ASOS MODIFICATION NOTE 21 (for Electronics Technicians)

SUBJECT : Firmware Upgrade for ASOS Light Emitting Diode Weather Indicator (LEDWI)

PURPOSE : Removal and replacement of U11 EPROM located on the Present Weather Sensor, Microprocessor Board S100-2MT2A1A1A3.

FIGURE -1 LOCATION OF FRU's IN LEDWI ELECTRONICS BOX

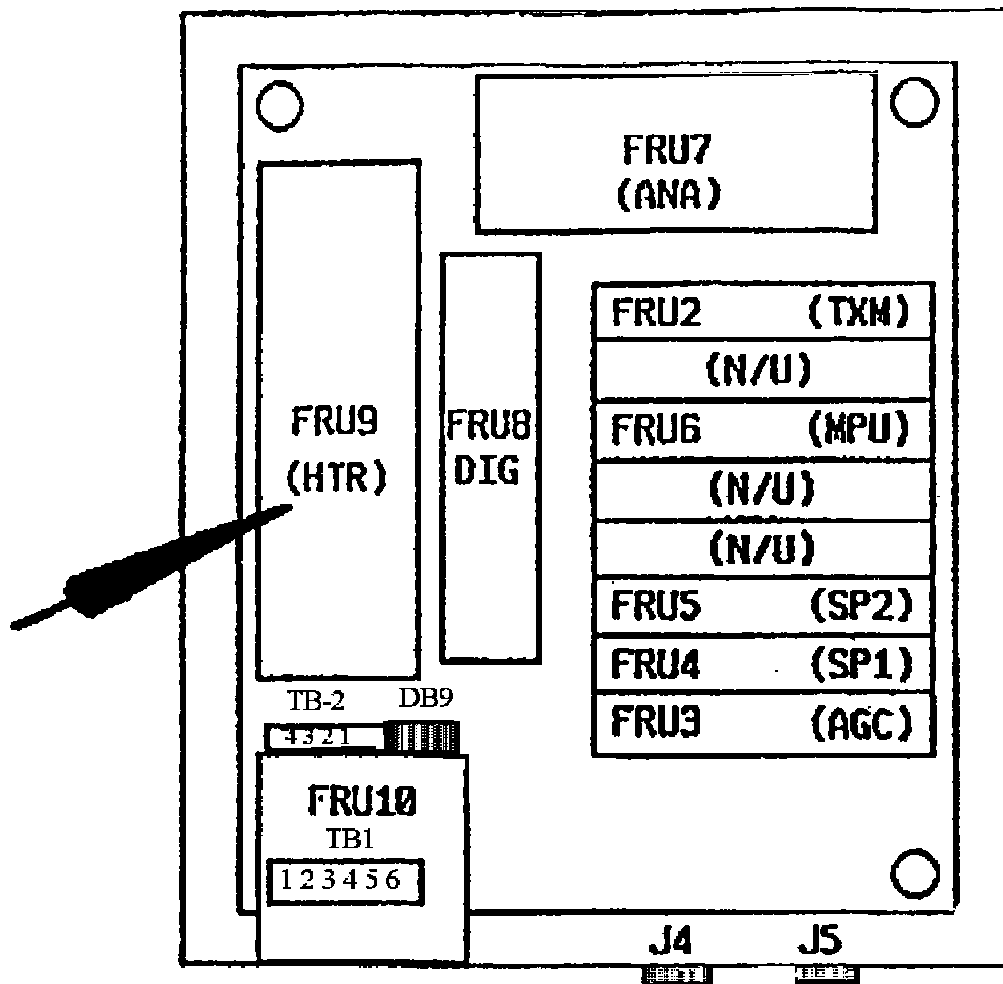
1. At the DCP, turn the LEDWI circuit breakers to "OFF".
2. At the LEDWI, open the electronics enclosure door.
3. Remove the MPU card located in the card cage, 3rd slot from the top. Refer to Figure 1.

1. Locate FRU9 using Figure 1.
2. Connect a DVM to FRU9 using Figure 2 as a guide. The (+) lead of the DVM connects to the (+ OUT) bifurcated terminal and the (-) lead of the DVM connects to the (-OUT) bifurcated terminal.
3. At the DCP, turn the LEDWI circuit breakers to "ON."
4. Adjust heater power supply voltage. Using Figure 2, locate R11(V. **Adj**) on FRU9. Adjust R11 clockwise until the DVM reads 28 ± 0.02 VDC. Read the DVM and record the voltage here: _____ VDC.
5. Heater power full load check and adjustment. Block the transmit beam for several minutes to turn on the hood heaters. After 2-3 minutes, determine if heaters are ON by feeling for heat.

FIGURE 2

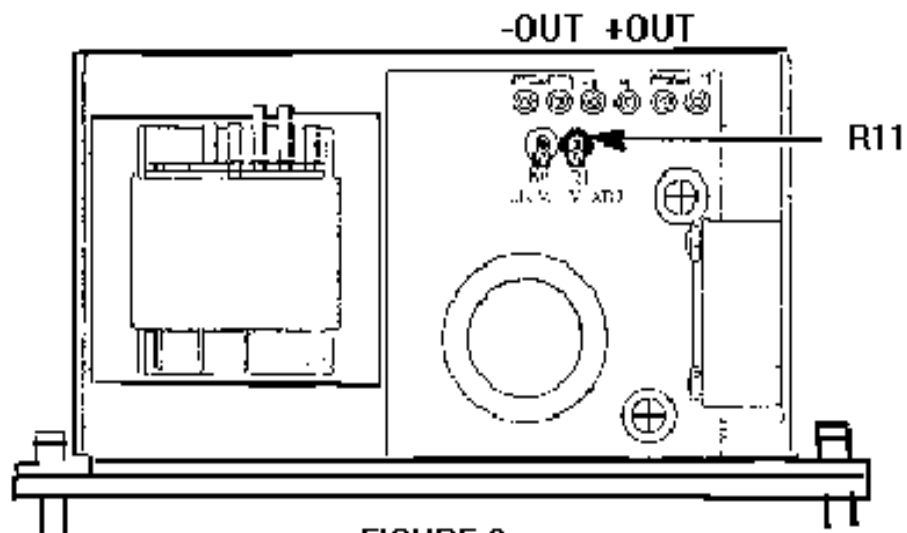
6. Read the DVM and record the full load voltage here: _____ VDC.
7. Verify that the full load voltage is within $\pm 0.5V$ of the nominal voltage set in step above.
8. Remove the block from the transmit beam.
9. Disconnect the DVM from FRU9.
10. Press RESET button on the MPU card.
11. Close and secure the door of the electronics enclosure.
